## Alternate Master Plan

In its comments on the public review draft of the Fish Creek Management Plan, the Department of Transportation and Public Facilities said:

Alternate Master Plan

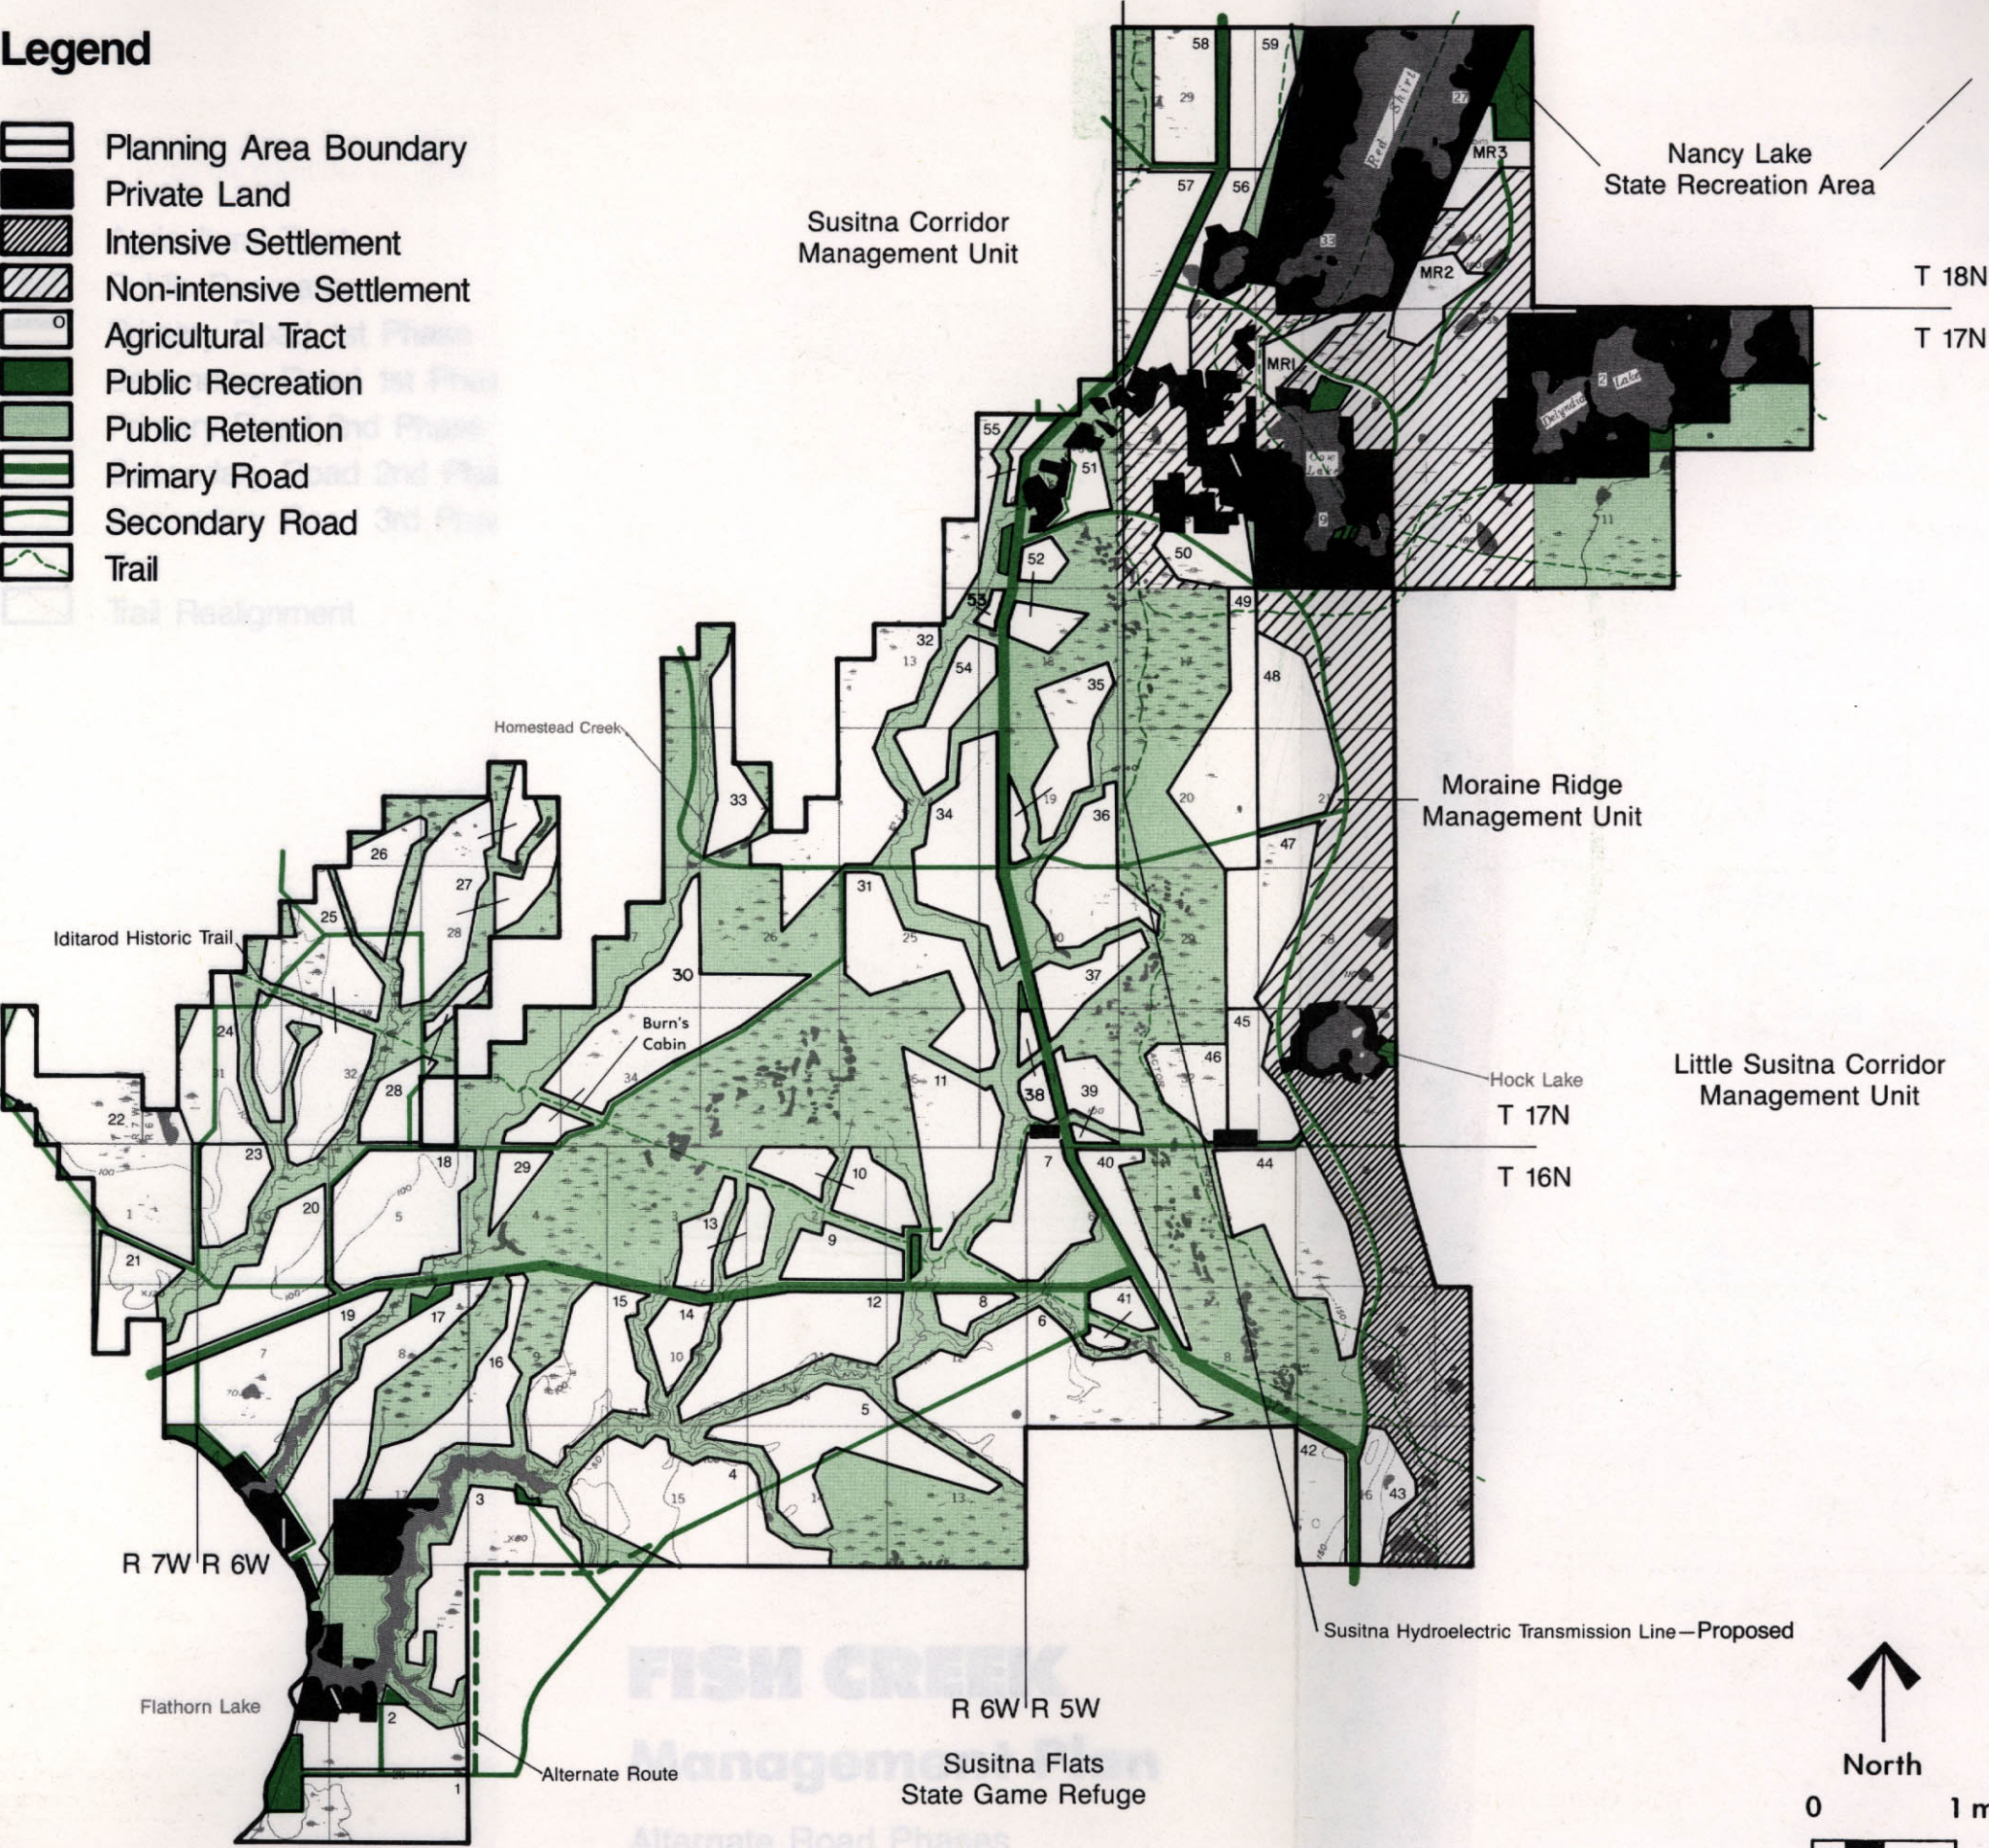
"Another issue is which alternative should be selected for the north-south primary access route. During the public meeting on this draft plan the Matanuska-Susitna Borough Planning Department and the Borough Planning Commission took the position that Alternative #1 was their preferred alternative, assuming approximately equal costs for construction and maintenance.

In satisfying this objective, we believe that Alternative #2 is superior. Our recommendation is that Alternative #2 be selected as the preferred corridor alignment in the Fish Creek Management Plan given the present level of limited materials and engineering data available to base this decision on. It is important to realize that this alignment will probably define the route of a future highway for the functional life of the right-of-way, rather than the functional life of any interim road.

1. Cost: We expect there will be substantial public pressure to upgrade this road to highway standards once it has been initially constructed. The information we have at present indicates that Alternative #2 will be less expensive to upgrade than Alternative #1.

Alternative #2 would result in a more centralized access alignment for the agricultural operations, but a less direct access for the proposed residential uses. It would also result in bisecting the agricultural area. This alternative would provide statutory protection to both sides of the north-south alignment through the agricultural area from traffic congestion created by future commercial and residential development along the route. Agricultural land use is highly compatible with a limited access highway. It can provide highway travelers with attractive viewsheds as well as

3. Design and Construction Standards: The horizontal and vertical alignment of Alternative #2 results in fewer and more gradual curves and consequently better sight distance than Alternative #1. At the 65 MPH design speed, 2300 feet of sight distance is the minimum required for passing. This factor will become increasingly important for traffic safety as the traffic volume increases. Traffic volumes can be expected to increase substantially as this route evolves from primarily an agricultural access road to a major arterial. It appears that Alternative #2 can generally meet the design requirements for a 65 mile per hour (MPH) design speed. Alternative #1 would not meet the criteria for rural highways over level ground."

Following receipt of these comments they were discussed in a meeting attended by representatives of the Department of Natural Resources, the Matanuska-Susitna Borough, and the Department of Transportation and Public Facilities. The compromise agreed to was that the plan would make clear that more information was needed before the decision on the selected route could be considered final and would leave the door open to reconsidering the alternate route. For this reason the following information adapted from the public review draft is presented here. It includes the alternate master plan, a chart analyzing the agricultural tract acreages in the alternate plan, and a comparison of the two primary road systems.

If Alternative Two is selected the location of the north-south corridor in Section 8, Township 16 North, Range 5 West or the location of the Iditarod Trail corridor should be adjusted during survey, if necessary, to minimize the impact of the road on the trail. The crossing should be as close to right angles as possible and overlap in the corridors should be kept to a minimum. It may be necessary to move the curve in the highway slightly south to accomplish this.
